**SAFETY EVALUATION REPORT**

**REQUEST FOR ALTERNATE DISPOSAL APPROVAL AND  
EXEMPTIONS FOR SPECIFIC HEMATITE DECOMMISSIONING  
PROJECT WASTE AT  
US ECOLOGY'S IDAHO FACILITY**

**January 15, 2014**

**Figure 3-1: Intruder Scenario Waste Concentration Assumptions**

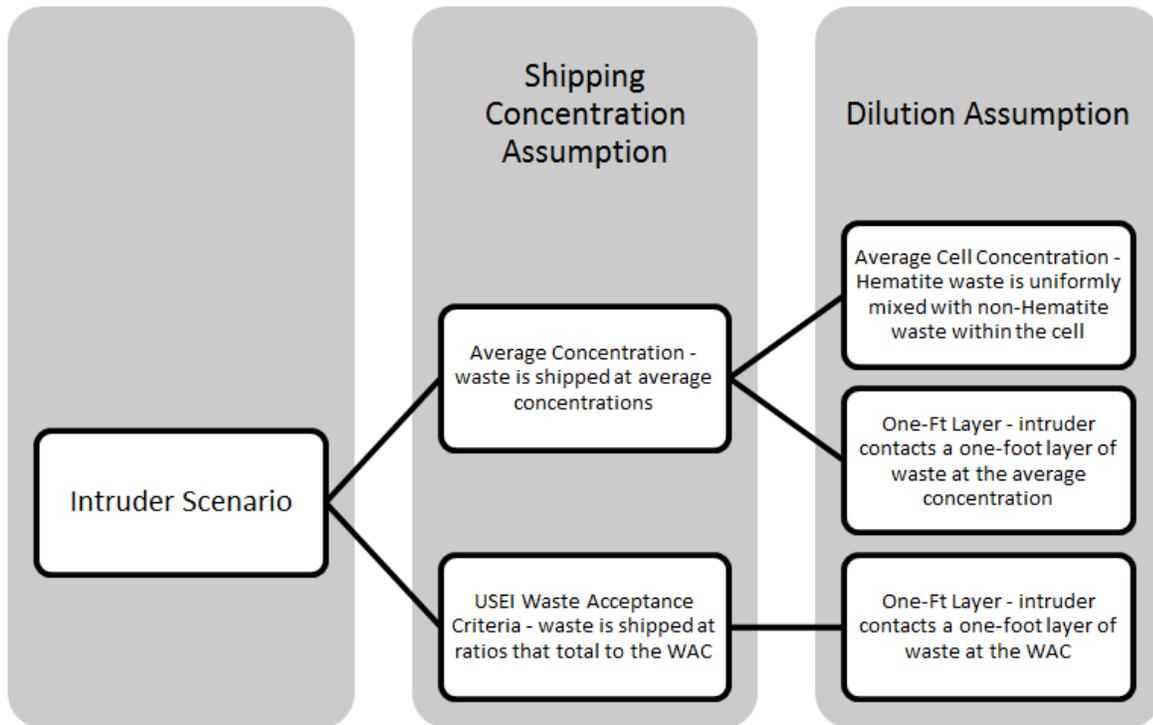
Table 3-6 shows the cumulative intruder doses for various assumptions, which are simply the sum of the doses assumed for the prior and current request. The maximum dose assumes the intruder encounters a 1 ft layer of waste at the WAC concentrations. The NRC staff notes that assuming an arithmetic sum for the cumulative intruder dose is unrealistic given that the intruder is not likely to encounter a separate 1 ft layer of the waste at the WAC concentration from all three requests in the same location. The total expected average concentration is approximately 18 times less than the WAC concentration of 3,000 pCi/g. The intruder doses assuming the intruder encounters waste at the expected average concentrations yield doses that are within a few millirem.

**Figure 5-1: Reactivity of uranium in matrix material versus concentration**

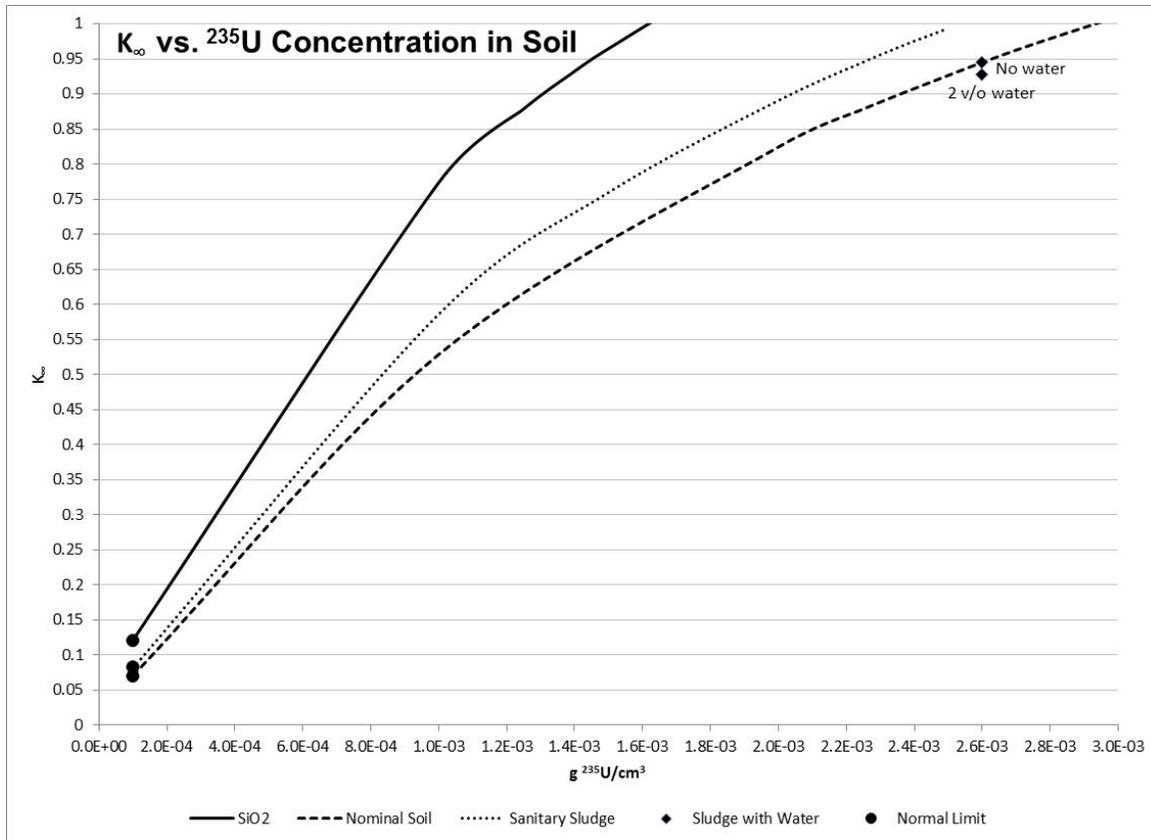
The staff performed a series of sensitivity calculations using the SCALE 6.0 computer package, to first confirm the results of calculations in NUREG/CR-6505, Vol. I, for  $\text{SiO}_2$  and nominal soil, and then to compare these results to waste with sanitary sludge as the matrix material. The staff varied the concentration of U-235 to verify the adequacy of the 0.1 g U-235/l limit for each of the matrix materials, and to determine the amount of safety margin in this limit. The safety margin was represented by the maximum safe concentration factor, which was taken to be the concentration at which  $k_{\text{eff}}$  exceeds 0.95 divided by the concentration limit of 0.1 g U-235/l. The staff also varied the concentration of water, although in general adding water to the waste material resulted in a net decrease in  $k_{\text{eff}}$ . The waste material was modeled as infinite in all three dimensions by applying mirror boundary conditions on a cuboid filled with a homogeneous mixture of waste consisting of the matrix material, fully-enriched uranium, and water. Because soil and sludge are highly porous materials, uranium and water were assumed to fill up the voids in the matrix material, so that the density of the matrix medium remained unchanged as uranium and water were added to it. (This maximizes the overall bulk density, though in an infinite system  $k_{\text{eff}}$  is insensitive to the bulk density.) For the sludge, certain isotopes were not represented in the SCALE Standard Composition Library (e.g., zinc and mercury, and only the As-75 and Ba-138 isotopes could be used). These trace materials were neglected, and the relative abundance of oxygen increased so the weight percent of all species totaled to 100%. The graph below shows the change in  $k_{\text{eff}}$  thus determined as a function of uranium loading, with no water present:

The staff's calculations showed that, over the whole range of uranium concentrations, SiO<sub>2</sub> is still the bounding matrix medium, and sanitary sludge (as modeled) is slightly more reactive than nominal soil. While the sludge contains more neutron poisons, its density is lower than soil (0.72 g/cm<sup>3</sup> instead of 1.6 g/cm<sup>3</sup>). Thus, at the same uranium concentration, uranium will have a higher relative concentration (in terms of g U-235/g waste) in sludge than in soil. Also shown are results for the sludge calculation closest to  $k_{\infty} = 0.95$  with no water present and with 2 v/o (volume percent) water. This shows that the addition of water results in a slight decrease in reactivity, so dry waste is the most bounding. The circles represent the case in which uranium concentration is at its normal limit of 0.1 g U-235/l, or 10<sup>-4</sup> g U-235/cm<sup>3</sup>. The results show that for SiO<sub>2</sub> soil, it would require the concentration to increase to 14.5 times its normal limit before criticality is possible. For nominal soil, the factor is 26.3 times the normal limit, while for the sanitary sludge, the factor is 22.7 times the normal limit.
